# Compal Confidential

## Schematics Document

### AUBURNDALE/CLARKSFIELD with Intel IBEX PEAK-M core logic Versace

REV:0.4

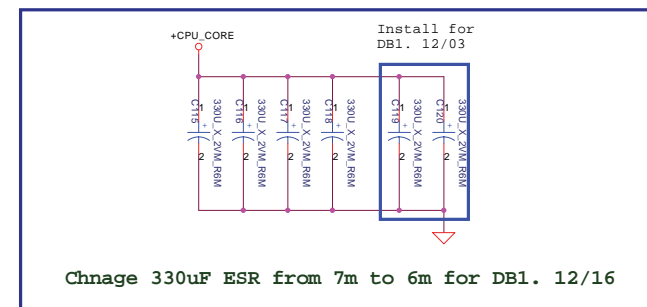
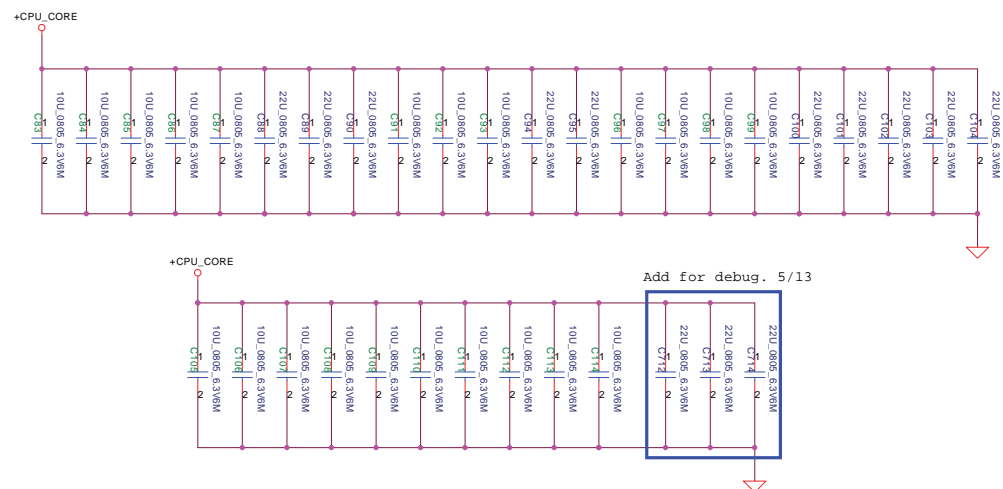
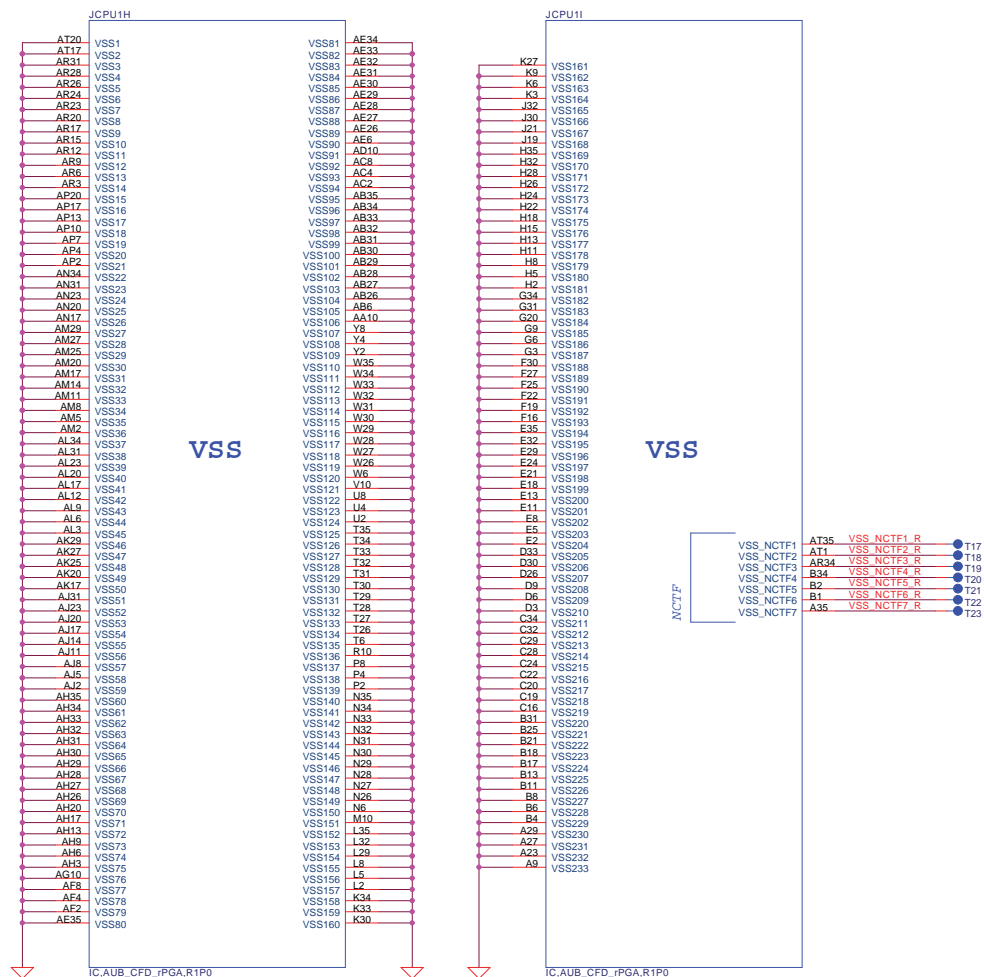
Change R5 to 220hm from 680hm. 11/30

Add C408. 11/30

6.8K to setup Q1 E-diode1. 12/04

Add PD R211 for FAN\_PWM. 11/30

Change from +1.5V. 7/8

Change R33, R34 value. 7/10

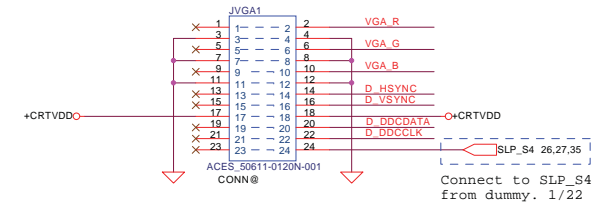
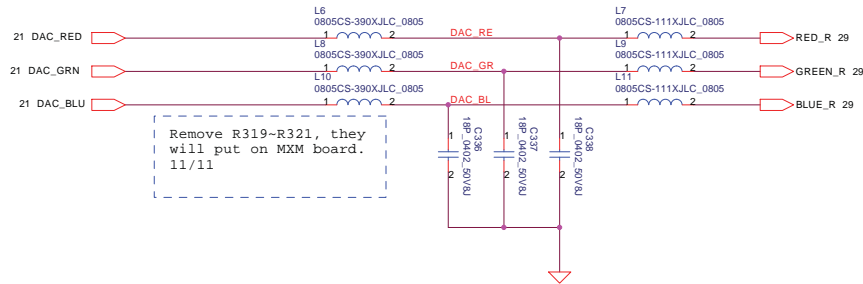
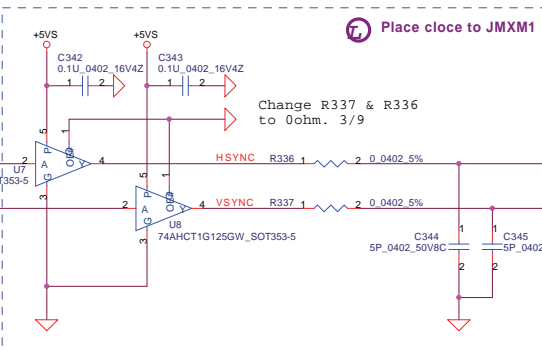
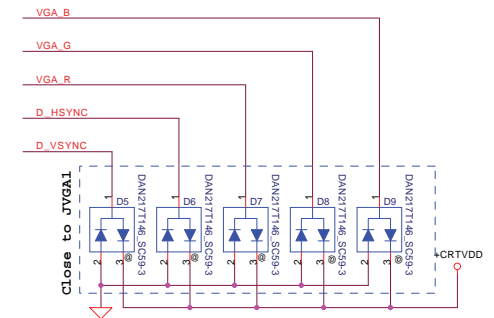
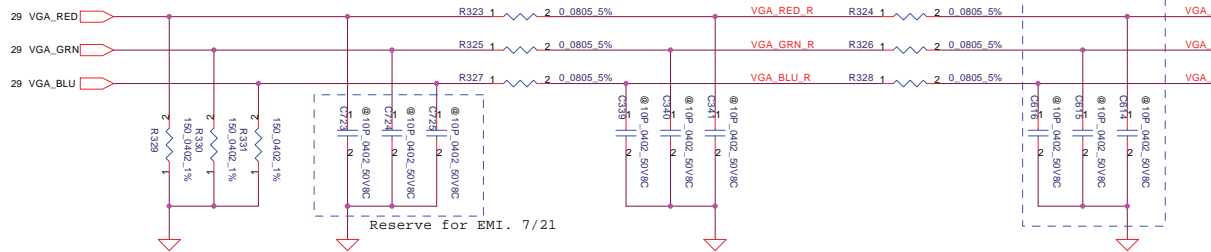
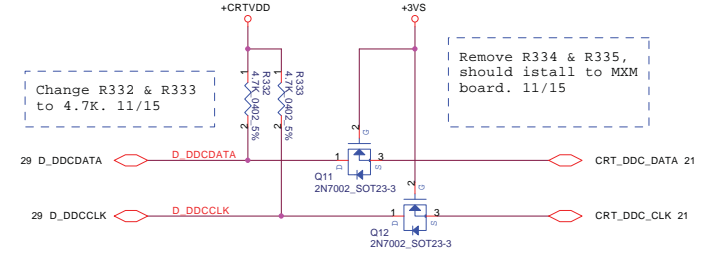
Add C614~C616 for Nvidia request. 11/15

Change R332 & R333 to 4.7K. 11/15

## LCD/PANEL BD. CONN.

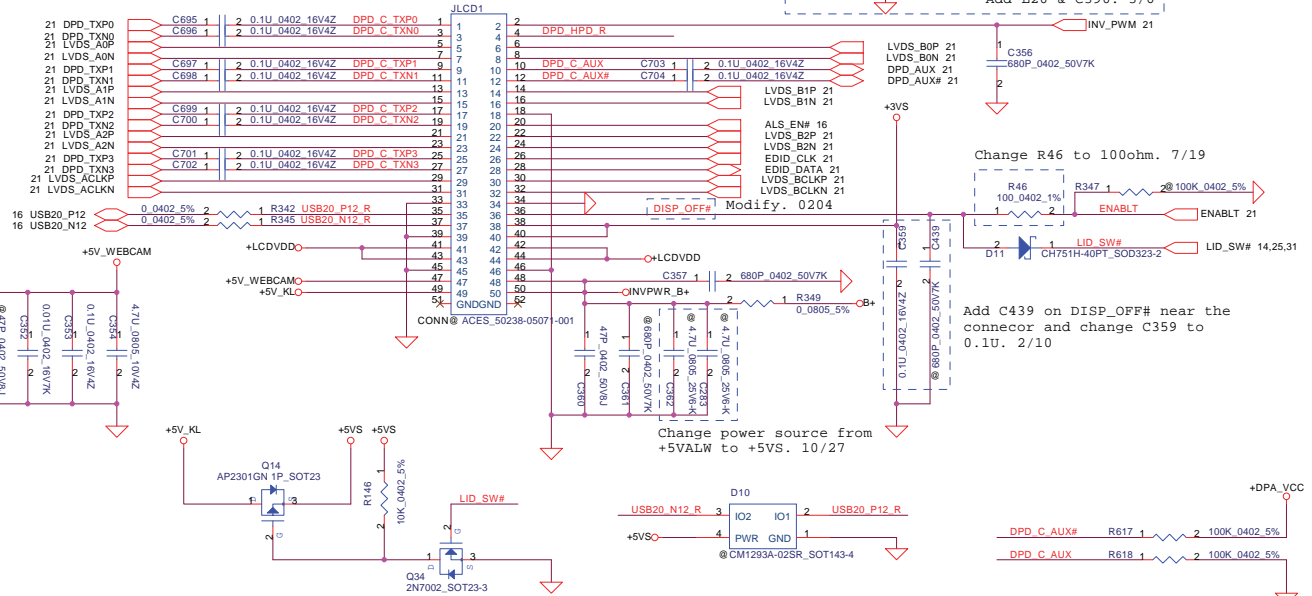
Modify pin assignment. 2/23

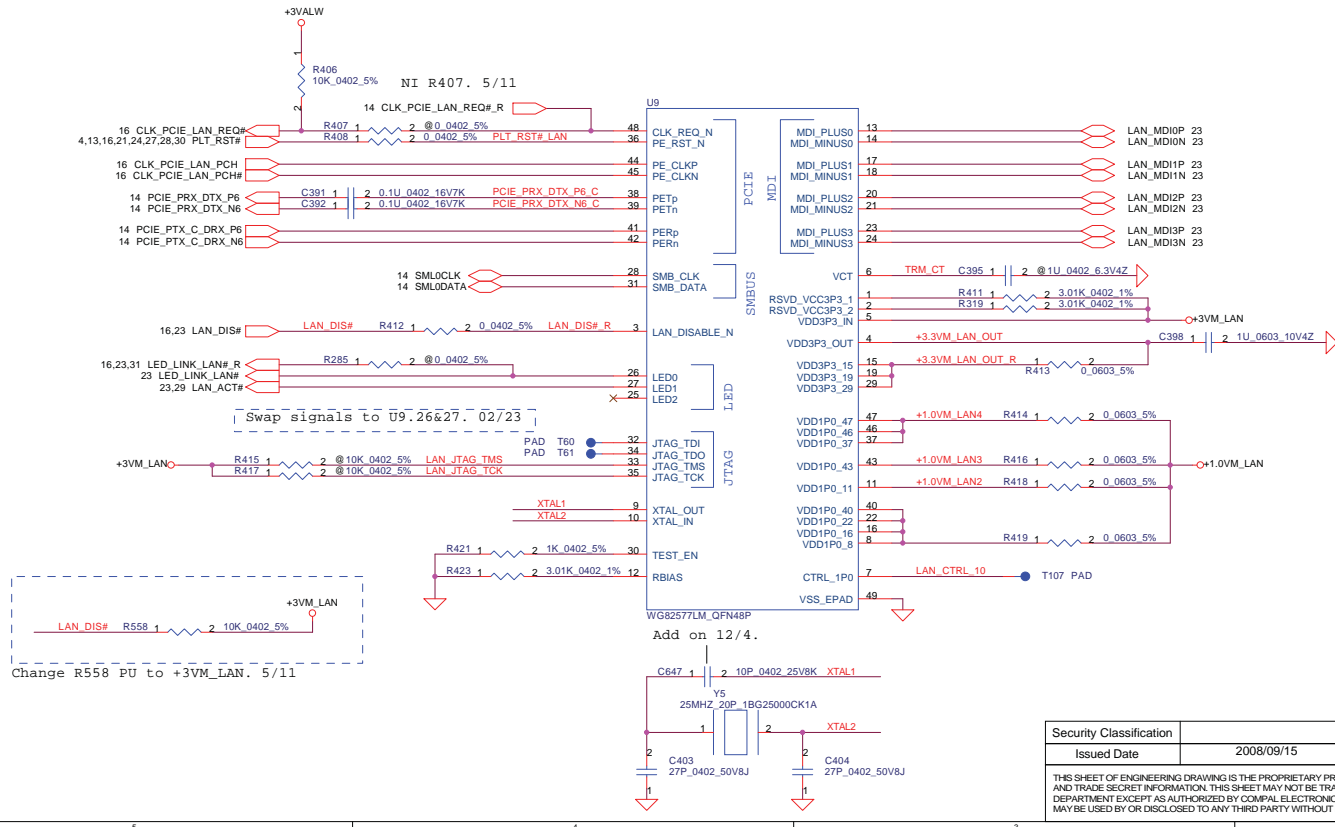
Remove C382, C383, C384, C385, C694, R401, R366, Q21 and R402 as not needed. 2/17

Remove C388, C389, C390, & C393 on +1.0VM\_LAN; Remove C394, C396 & C397 on +3.3VM\_LAN\_OUT\_R; Remove C399 & C400 on +1.0VM\_LAN4; Remove C401 on +1.0VM\_LAN3; and Remove C402 on +1.0VM\_LAN2 as done in Intel's RedFort CRB

Remove Q17, R124, and R405 (Intel confirmed isolation not required for Hanksville)

Remove R354, R355, Q22A, Q22B; and connect SML0CLK and SML0DATA directly to LAN\_SM\_CLK and LAN\_SM\_DAT. 2/23

Change R558 PU to +3VM\_LAN. 5/11

**Audio/Express/LEDs/Card Read Connector**

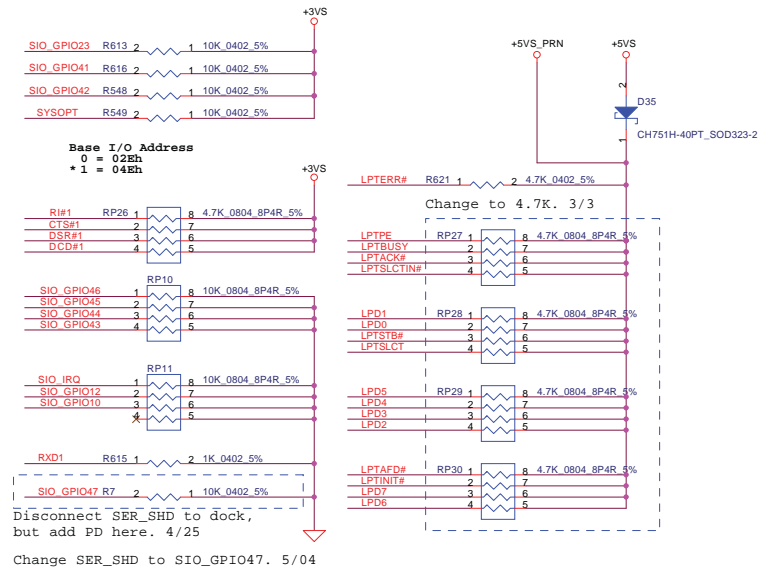
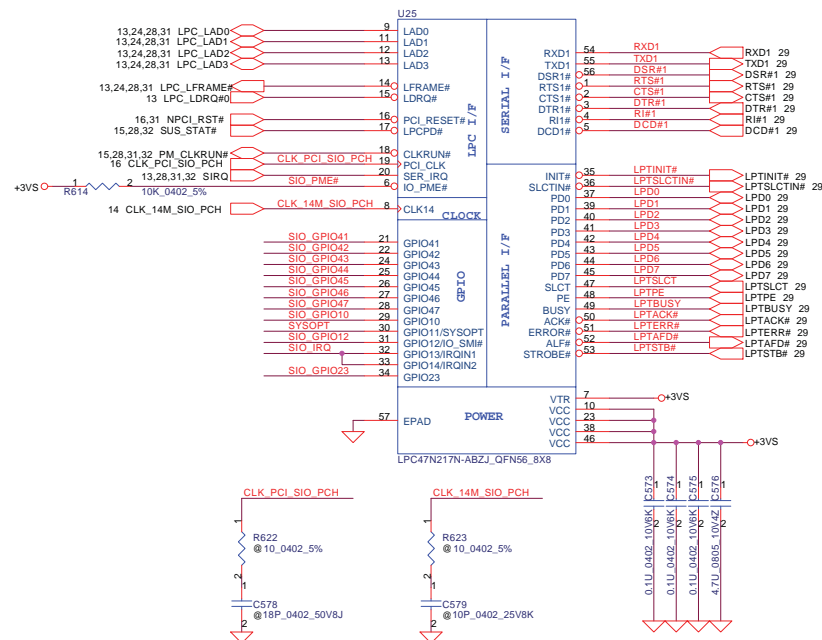
Removed Power button JPB1 & C522, combin with JSWITCH1. 11/10

Change R734 & R735 to NI. 02/06

Add 1 pin for +1.5VS. 4/29

Change CLKREQ\_EXP# to CPPE# and connect to GPIO14. 7/21

Change net name from DOKK\_HPS#. 11/11

Change net name from A\_SD. 5/04

Change net name from EAPD. 5/04

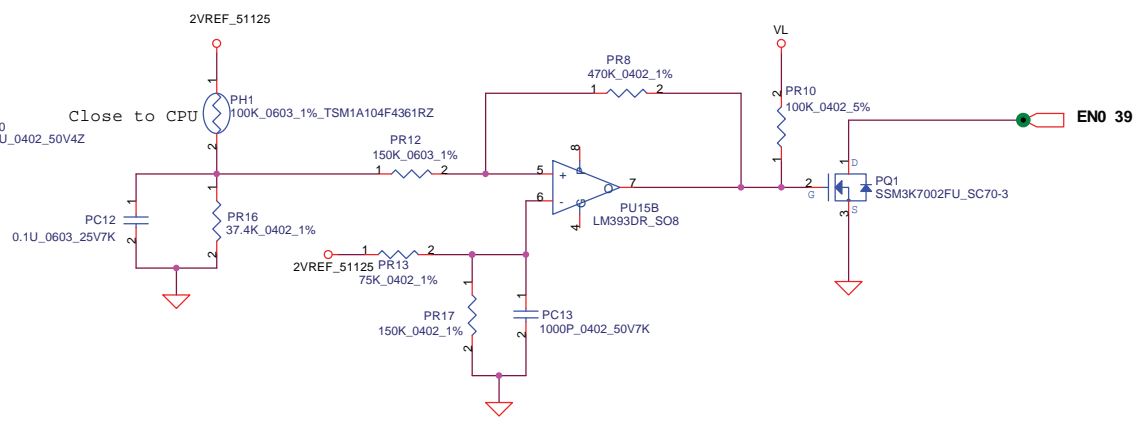
PH1 under CPU botten side :  
CPU thermal protection at 90 +-3 degree C  
(Need to be checked)
